Product Change Notification
Software Release Notice

MultiTech[®] Conduit[®]
Family of Programmable Gateways:
Conduit IoT Programmable Gateway
Conduit IP67 Base Station,
and Conduit AP Access Point

mPower[™] Edge Intelligence
mPower 5.2.X Firmware Available

Product Change Notification Number
PCN 06022020-001

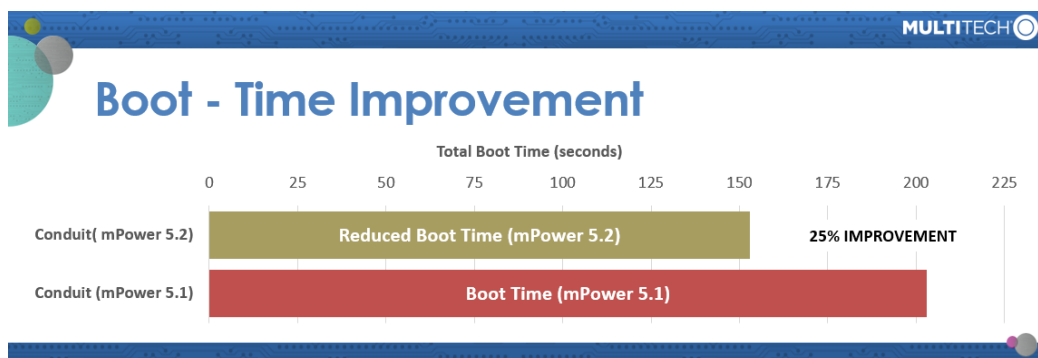
1. **Reduced Boot Time** Previous versions of mPower resulted in longer boot times. mPower 5.2.X includes new features and optimization that decrease the device boot time up to 25% [GP-256, GP-360, GP-362, GP-363, GP-364]

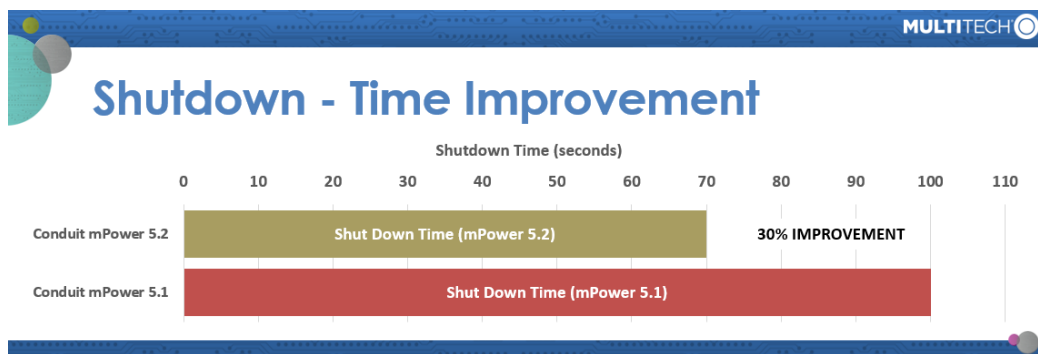
2. **Shutdown Time Optimization:** When restarting a device, the total time to reboot also includes shutdown time. Previous versions of mPower resulted in longer shutdown times. mPower 5.2.X has been updated to reduce shutdown time. Conduit mPower shutdown time has been shortened by 30%.

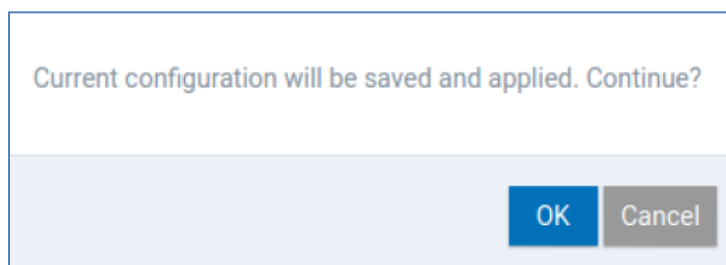
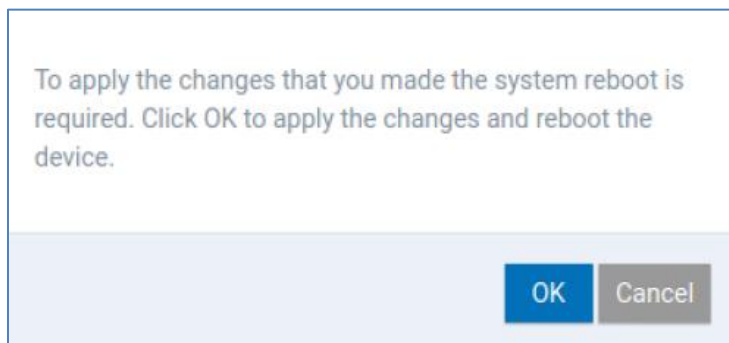
3. **Save and Apply Configuration Settings without Restarting:** Previous versions of mPower required a device reboot for most system configuration settings. mPower 5.2.X has been updated to save and apply many configuration settings without the need to restart. In these cases, the user will be presented a “Save and Apply” button after making configuration settings. If “Cancel” is selected, changes are not saved. [GP-339]

A limited number of system configuration setting changes will still require the device to be restarted. In these cases, the user will be presented with a “Save and Reboot” button after making configuration settings. If “Cancel” is selected, changes are not saved.
